Resubmittal 2

Colby Rezoning and Subdivision
15635 Pecos Street

Please see our responses to each comment inline below, in red:

Proposed Site Plan:

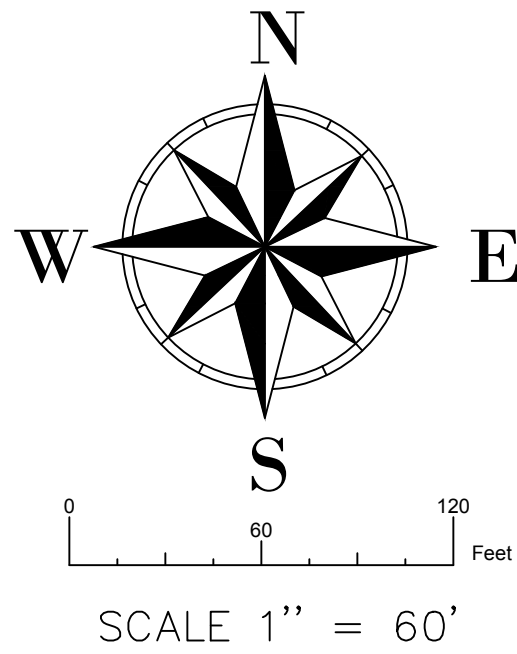
---PLN4: Thank you for responding to this. However, the placement of the hypothetical building on the proposed southern lot seems to be within the setback of the current location of the septic systems.

As it stands now, that lot is not buildable if it encroaches the septic setback. Please show the buildability in a different way, either on a different part of the lot or by moving the septic systems. Moreover, each lot must have its own septic system in its entirety on its lot. The system cannot be partly in a different lot. Please refer to the Environmental Analyst for further details about septic and septic location.

ENV4. The septic system, including its leach field, for each proposed lot will need to be contained within the boundaries of that lot with appropriate setbacks. The design as shown is not permissible with the lot line bisecting the septic field.

ENV5. Per ACHD Regulation O-22, setback distances from septic tanks, pipes, and soil treatment areas (also called leach fields) must be maintained. The regulation, including setback requirements, can be found at <https://adamscountyhealthdepartment.org/septic-system-and-use-permits>.

ENV6. The lot has to be buildable to meet requirements of minimum building size for the zone district, size of septic system tanks, leach field, and components. Setbacks must be met. The size of the septic system will increase with the size of the dwelling proposed, as outlined in ACHD Regulation O-22. Please demonstrate these requirements can be met for the proposed project.

Please see the proposed site plan ([pg. 8](#)), on which the proposed septic systems fit entirely on each given lot. As shown, our current septic system will be abandoned, and we will build a new one that fits, in its entirety, on the northern lot. Per our phone conversation with Megan Grant (Environmental Analyst) and in accordance with ACHD Regulation O-22, the proposed site plan meets septic requirements.

As shown on the proposed site plan, the proposed septic systems will not cross lot lines.

Acknowledged. The proposed site plan ([pg. 8](#)) indicates that all requirements and setback distances can be maintained.

Our proposed septic systems (including leach fields) will not cross lot lines, so no easement should be needed. See proposed site plan ([pg. 8](#)), which demonstrates that the new septic systems will not need to cross lot lines.

IMPROVEMENT SURVEY PLAT
LOT 8, BLOCK 1, NORTHWEST ESTATES, BEING A PART OF THE NORTHWEST ONE-QUARTER OF SECTION 9, TOWNSHIP 1 SOUTH, RANGE 68 WEST OF THE SIXTH PRINCIPAL MERIDIAN, COUNTY OF ADAMS, STATE OF COLORADO.

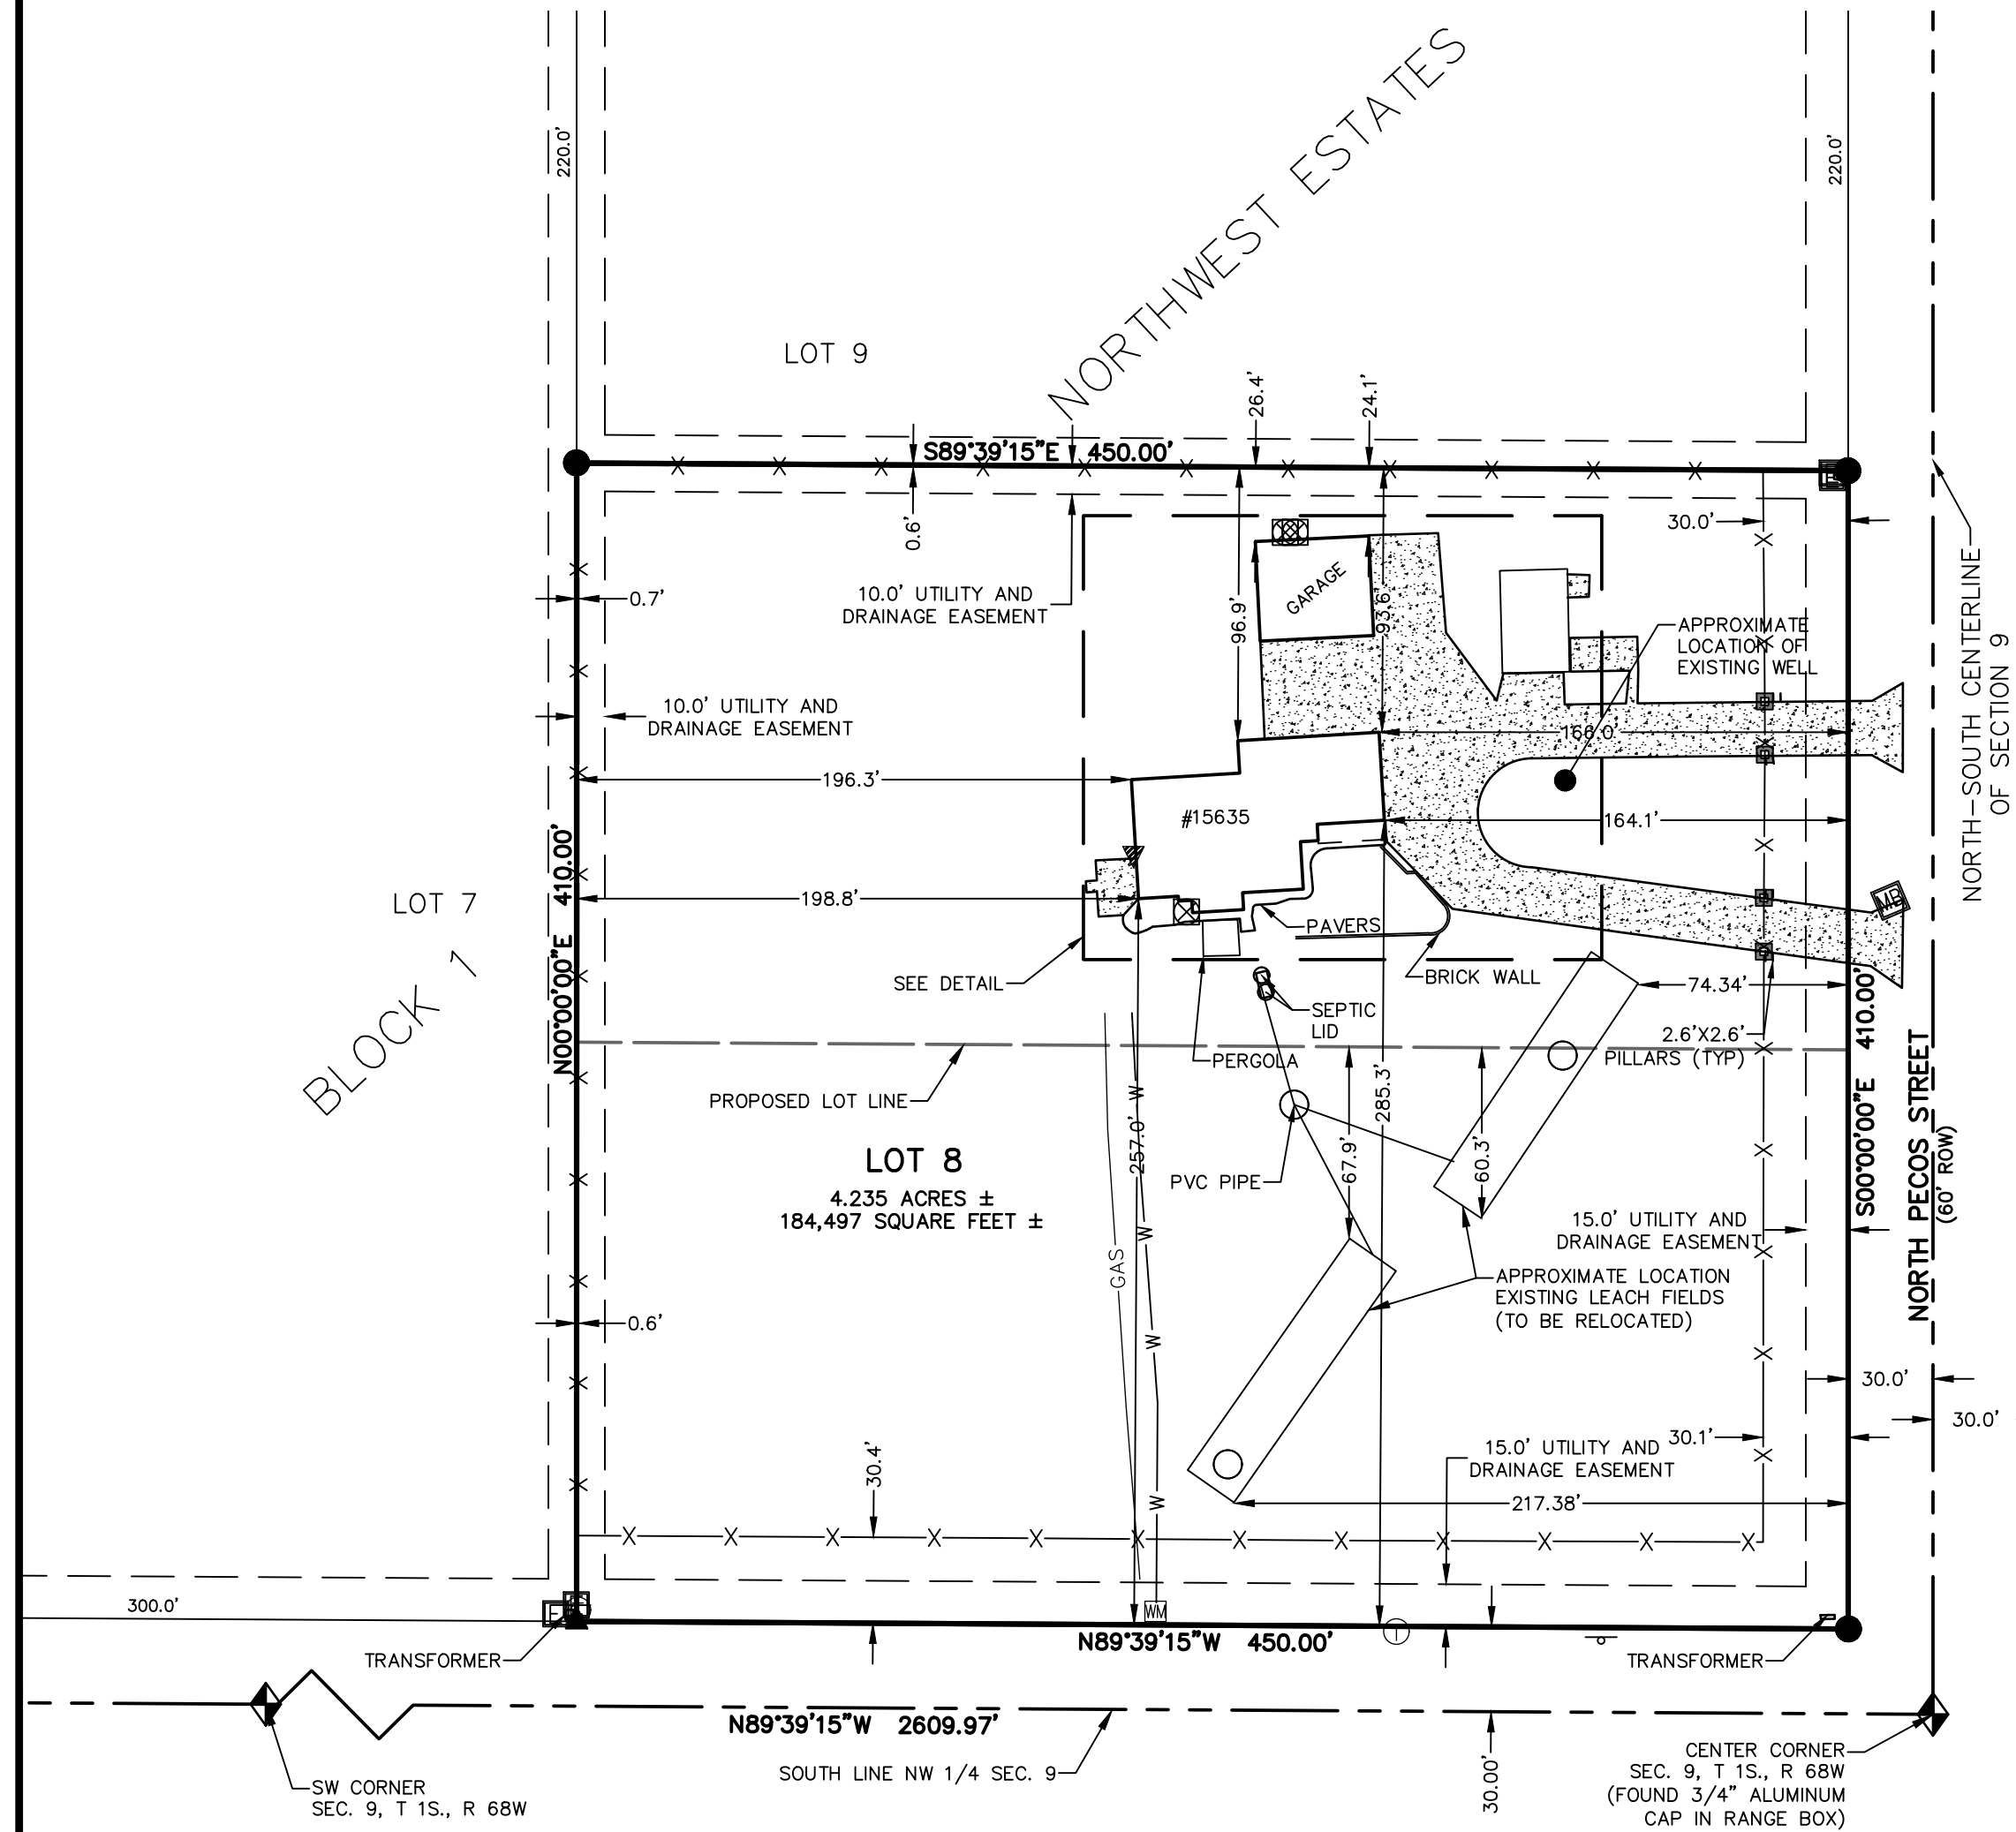
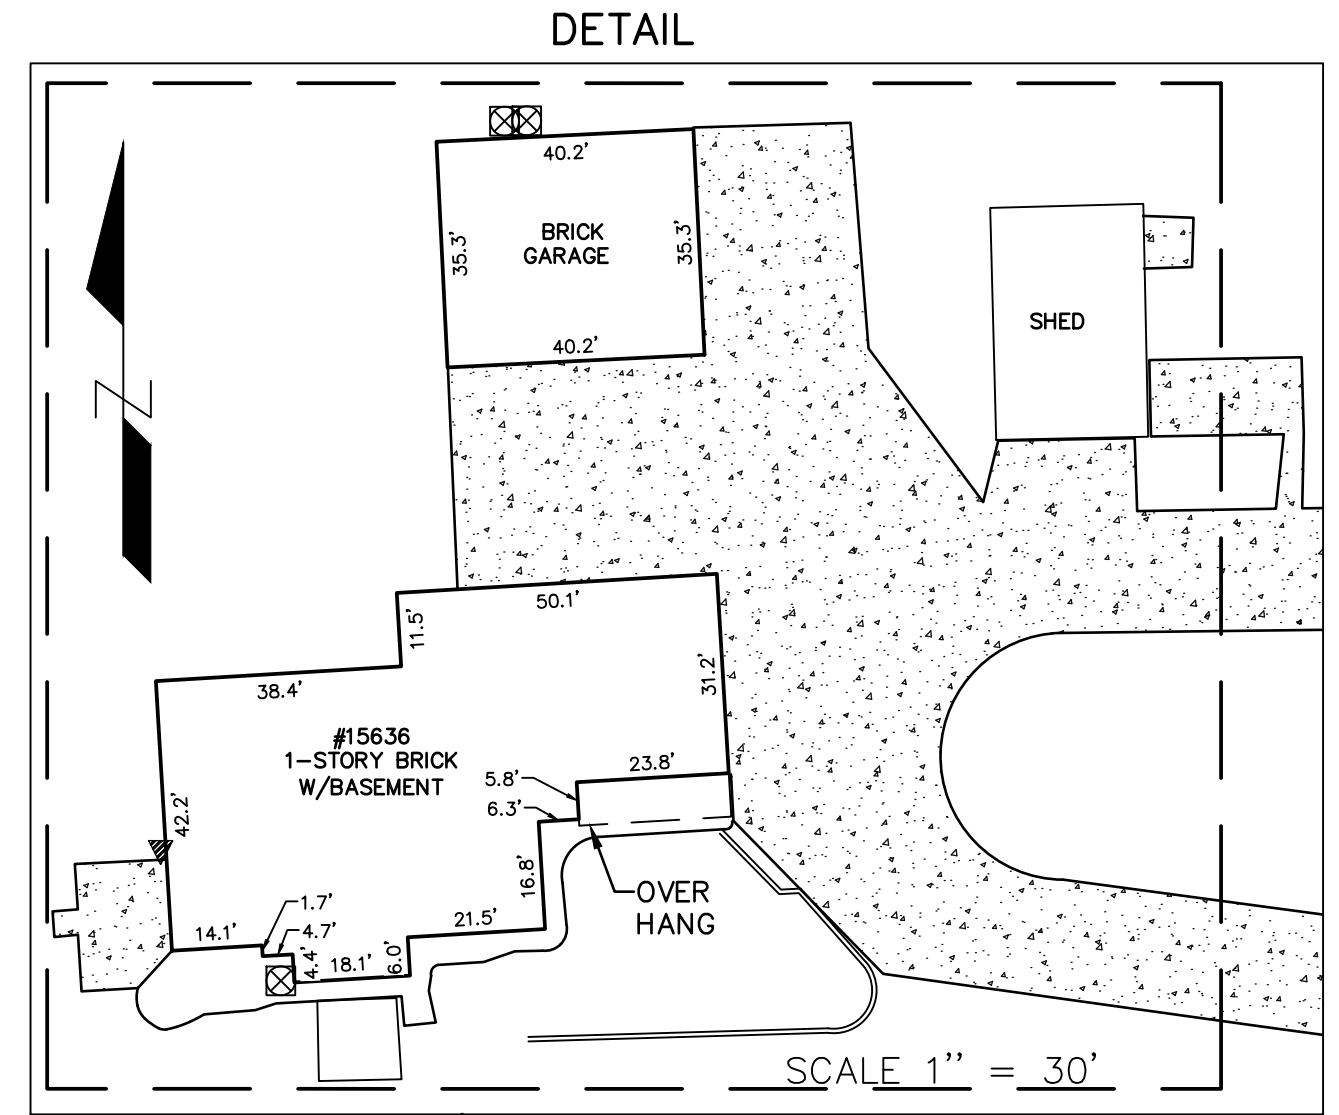
ENV3. Please provide an updated site map/plat that indicates the location of the existing water well, septic system, and distances between the site features and the septic components for the current residence. The provided plat/site map provides location of leach fields (actual or proposed?) but not locations of structures, septic system components (tanks, piping), or distances.

3. The **current plat** ([pg. 9](#)) shows the location of the existing septic system and leach fields that will be abandoned upon subdividing.
4. The **proposed plat** ([pg. 10-11](#)) does not show any of these features, per guidance from David Dittmer (Right of Way Agent).

COLBY SUBDIVISION

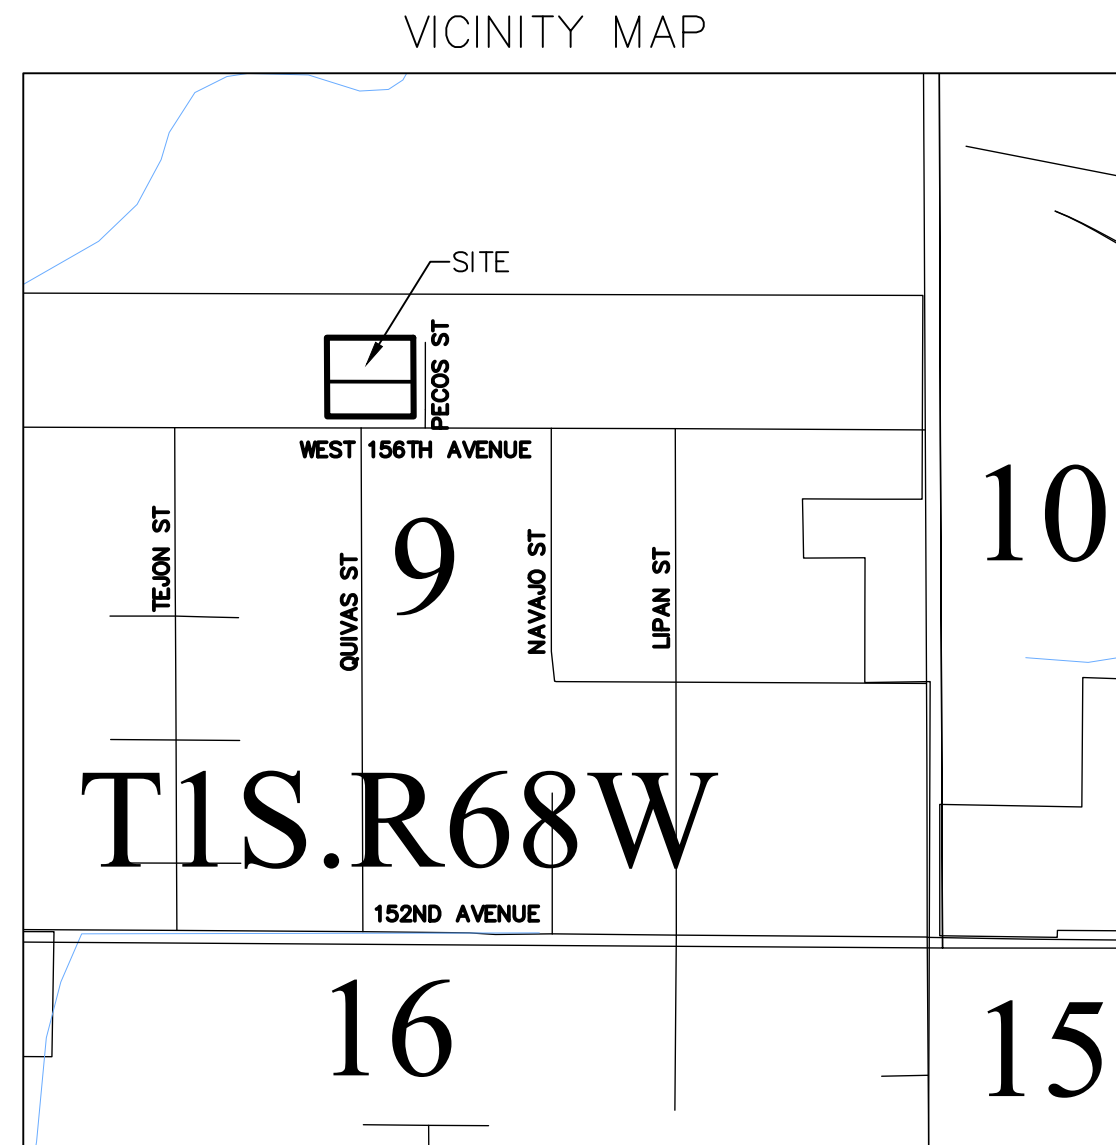
ENV1. Existing water well (Permit 108938) on subject parcel, installed in 1981. Comments from DWR letter indicate that existing water well on subject parcel must be addressed prior to development, among other requirements. Please provide documentation of communication and disposition of DWR requirements for Adams County review.

Plat note added to indicate a re-permit of existing well permit no. 108938 is required.

See plat note 14 on proposed plat ([pg. 10](#)).
